Product/Process Change Notice (PCN)

PCN Number: PCN_AsSBRRO_20250114

Affected Series: WA-SBRRO

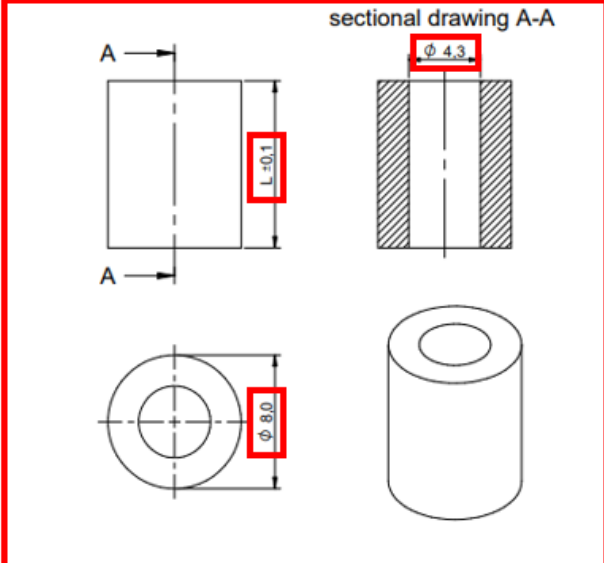
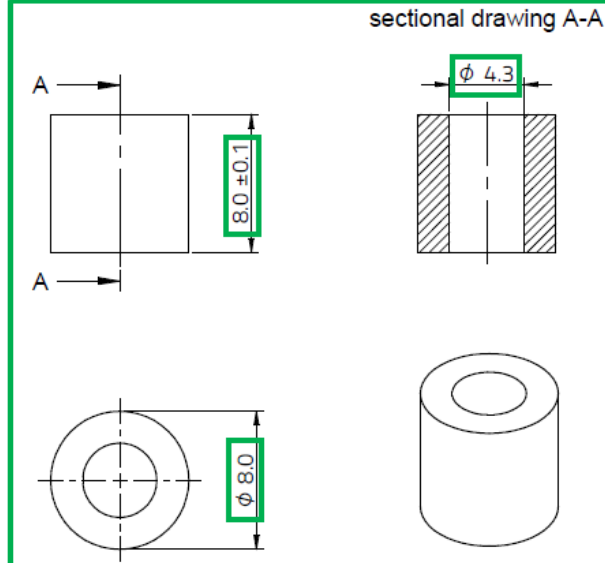
Because of a database mismatch, Würth Elektronik eiSos correct 3D models & datasheets.

Würth Elektronik eiSos will update the dimensioning from an indirect dimensioning to direct dimensioning. The table will be removed and all dimension values will be shown directly in the drawings.

Before change	After change						
<p style="text-align: center;">sectional drawing A-A</p>  <p>Article Properties:</p> <table border="1" style="width: 100%; border-collapse: collapse;"> <thead> <tr> <th style="background-color: #cccccc;">Properties</th> <th style="background-color: #cccccc;">Value</th> <th style="background-color: #cccccc;">Unit</th> </tr> </thead> <tbody> <tr> <td>Length</td> <td>L</td> <td>8 mm</td> </tr> </tbody> </table>	Properties	Value	Unit	Length	L	8 mm	<p style="text-align: center;">sectional drawing A-A</p> 
Properties	Value	Unit					
Length	L	8 mm
